RE: Mayhew Pit, File No. M-2024-054, 112 Construction Materials Reclamation Permit Application, Preliminary Adequacy Review

The Division of Reclamation, Mining and Safety (Division) has completed its preliminary adequacy review of your 112 Construction Materials Reclamation Permit Application submitted for the Mayhew Pit located in Bent County. All comment and review periods for the application began on April 23, 2025, when the application was called complete for filing purposes, and ended on June 18, 2025. The decision date for the application is currently set for October 22, 2025.

Mayhew Pit #M2024-054

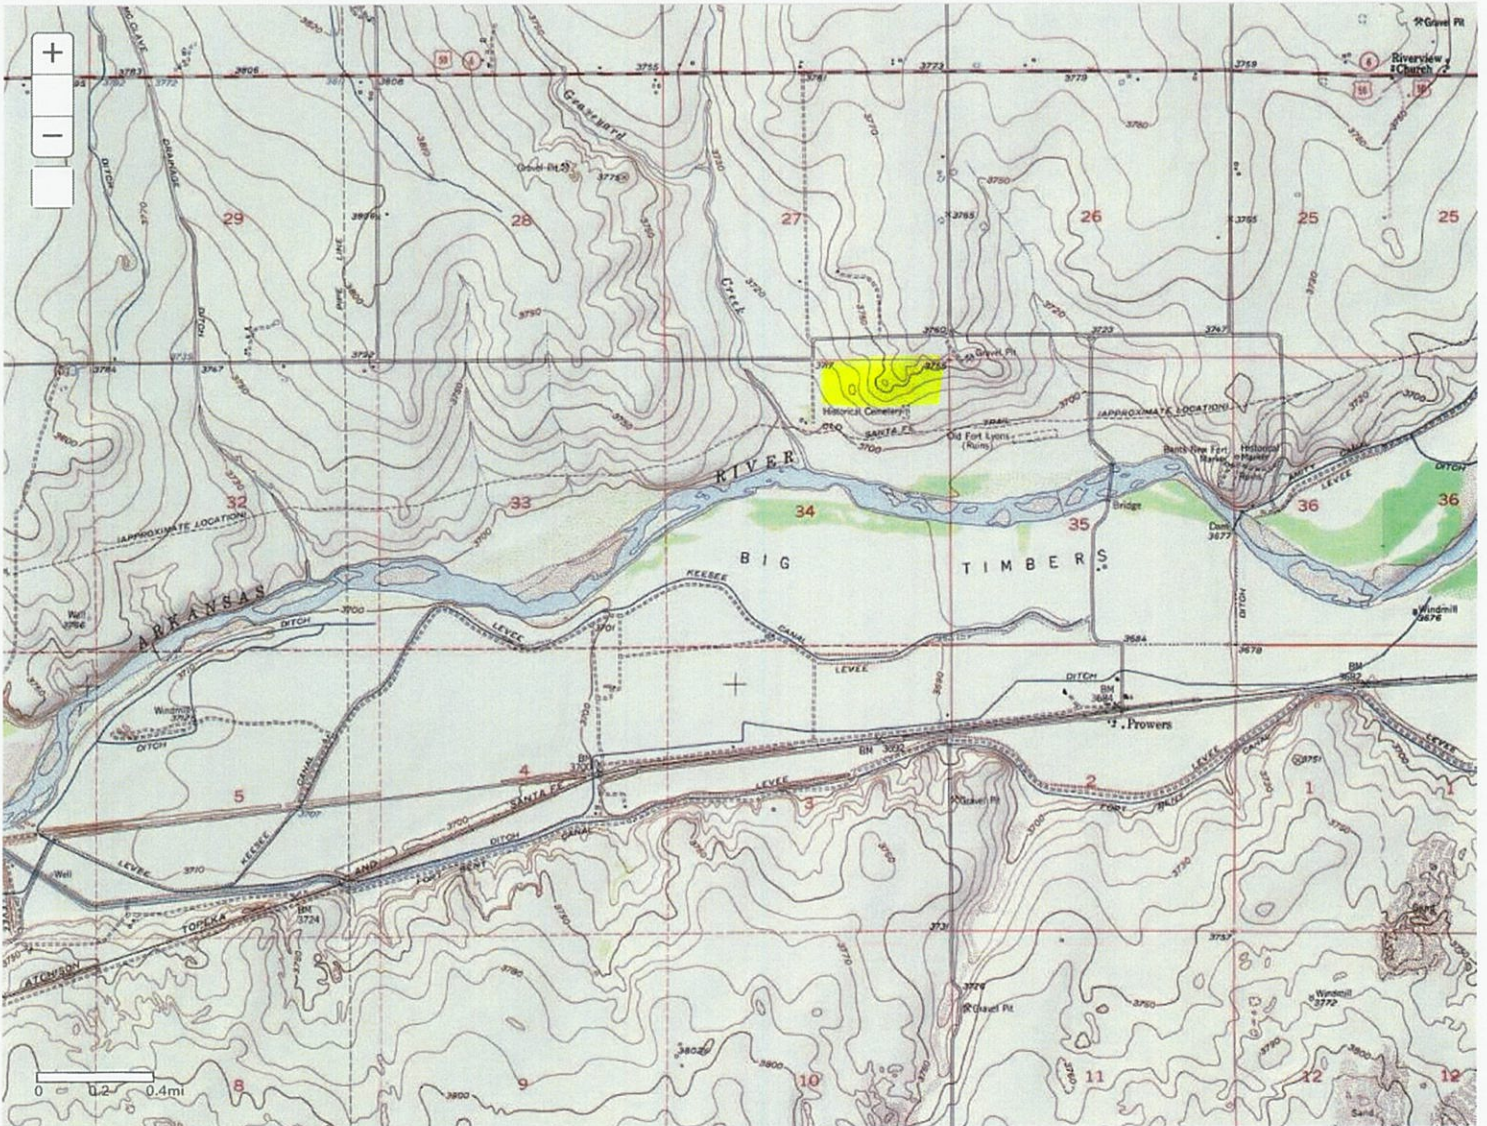
- 6) Please provide a revised Exhibit B that properly titles the 3 maps submitted on April 18, 2025 (see enclosed):
 - a. The map with the USGS topographic map layer needs to have a title related to Exhibit B. For example, if this is the first map for the exhibit, it could be titled “Exhibit B – 1. Topographic Map”.

- 7) In addition to the above items, please revise the following for the Exhibit B maps:
 - a. The USGS topographic map and the index map need to show the correct geometry of the proposed permit area which is shown on the aerial photograph map with the mine entrance coordinates.

Exhibit B-Index Map

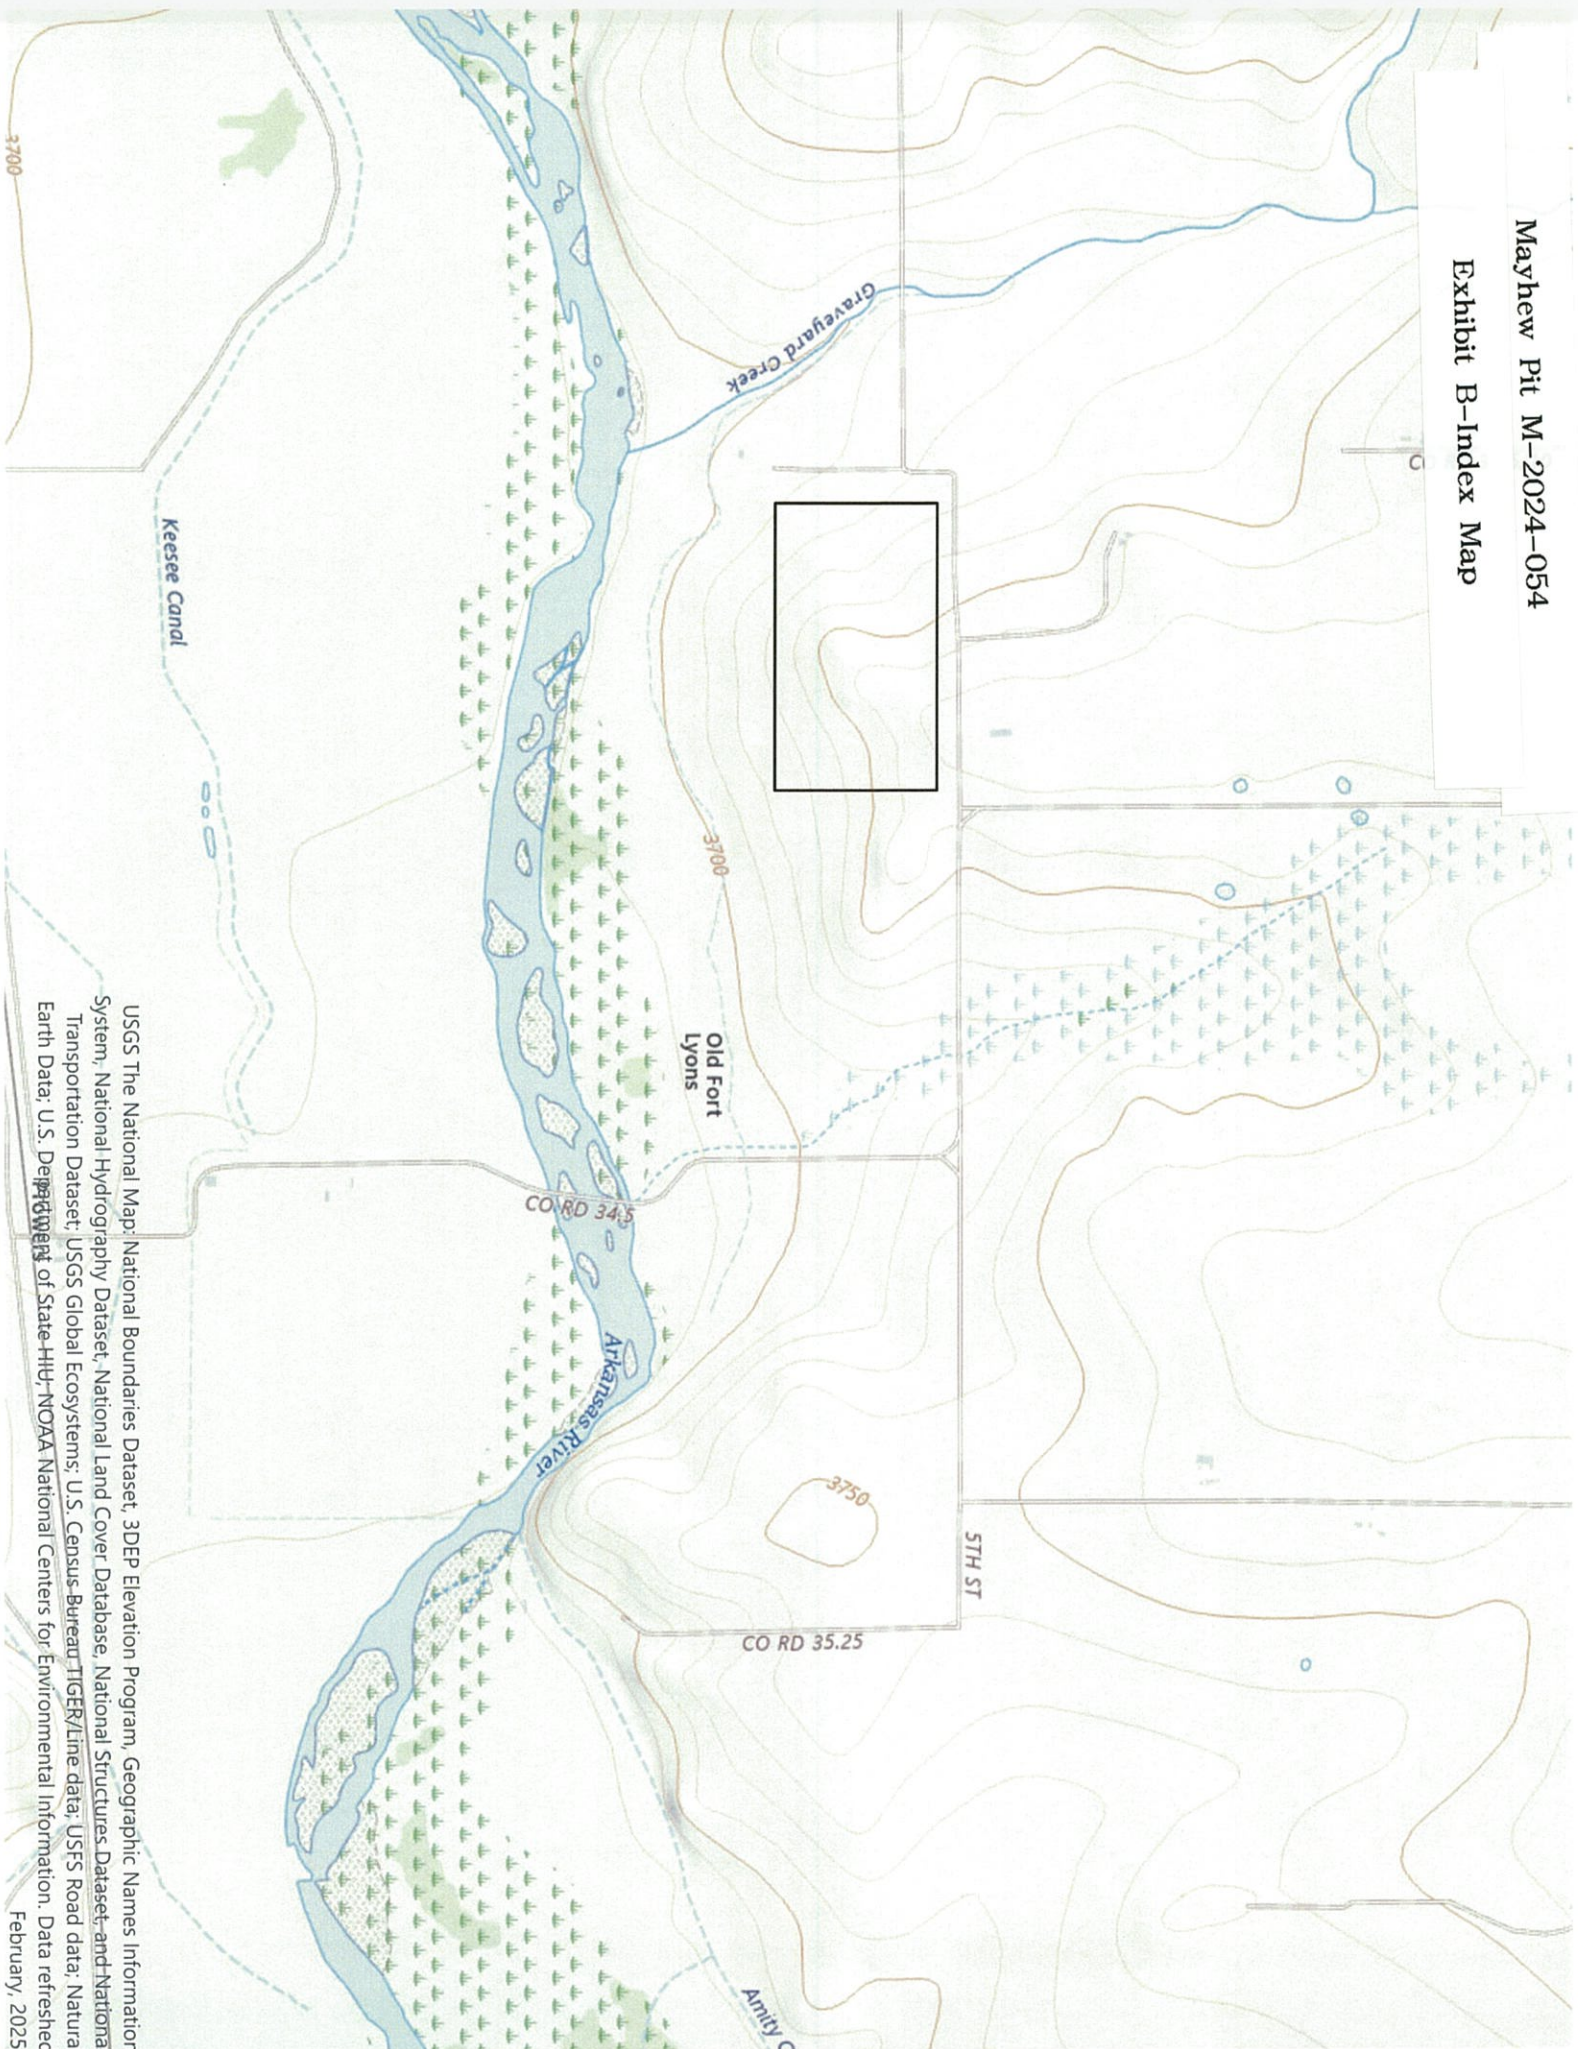
- b. The map with the current title of “Exhibit B – Index Map” needs to be retitled in order of the 3 Exhibit B maps. For example, if this map is after the topo map, it could be titled “Exhibit B – 2. Index Map”.

- b. The main entrance to the mine site should be located at the proposed permit boundary where the main access road enters the mine site. Therefore, please update the map with the coordinates to ensure the coordinates reflect the proposed primary entrance to the mine site. (Note this item can be disregarded if the entrance road off of County Road JJ is added to the permit area.)
